© 2015 Mazda Motor of America, Inc.

Subject: RATTLE NOISE FROM HEADER PANEL OF CONVERTIBLE TOP	Bulletin No: 09-045/15
	Last Issued: 12/23/2015

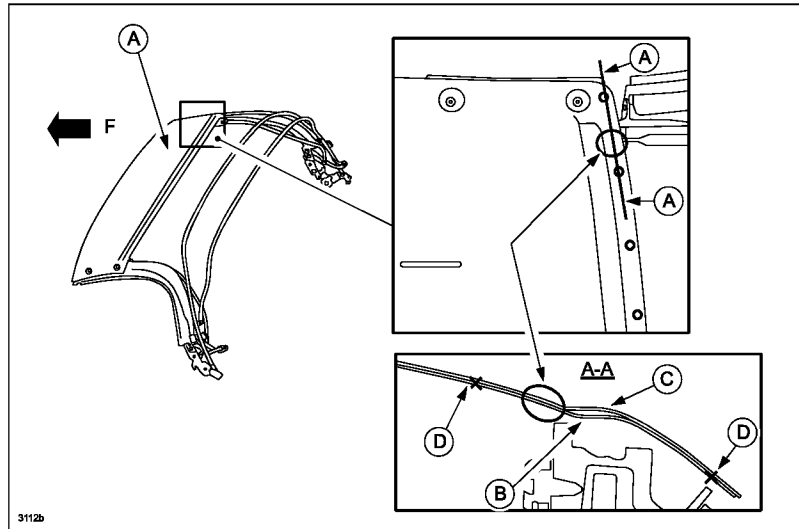
Some vehicles may exhibit a rattle noise (A) from the header panel (B) of the convertible top when driving on a rough road.

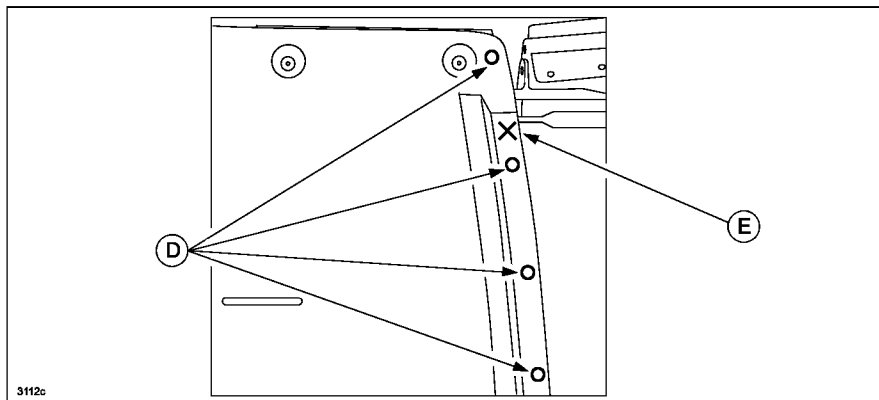
The header panel (A) is formed by two aluminum panels, inner (B) and outer (C). When receiving an input force by driving on a rough road, the two panels at the problem area, where spot welds are located (D), may warp and change relative position causing the rattling noise. (F=Front)

To correct the problem, a spot weld (E) has been added to the problem area, where the original spot welds are located (D), to increase the rigidity and prevent the warping.

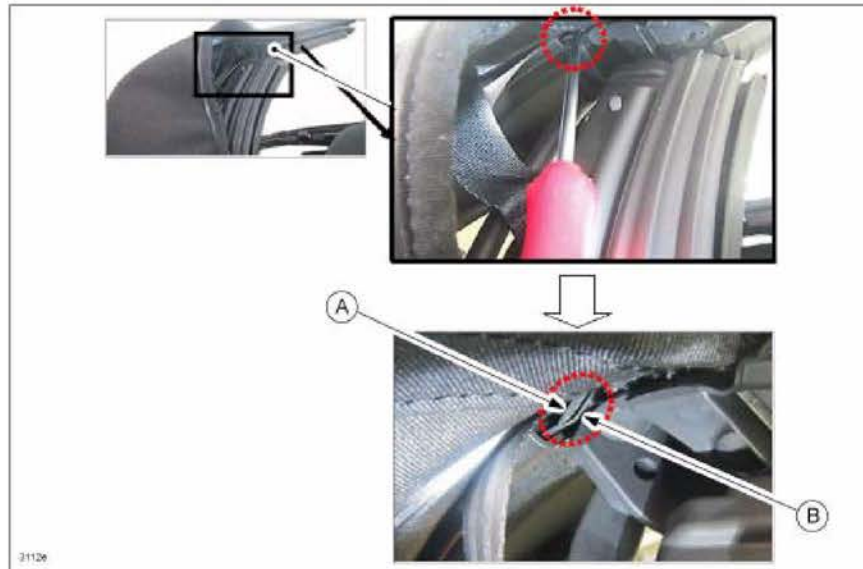
1. Verify customer concern.
2. Enlarge the gap between the inner and outer panel of the header panel at the problem area (both driver and passenger sides) using the following procedure.
 - a. Open the convertible top to a position where the area to work (A) is the most accessible as shown.

- b. Using a flat-blade screwdriver with protection tape on the tip, enlarge the gap between the outer (A) and inner (B) aluminum panel of the header panel about 1-2mm at the problem area.
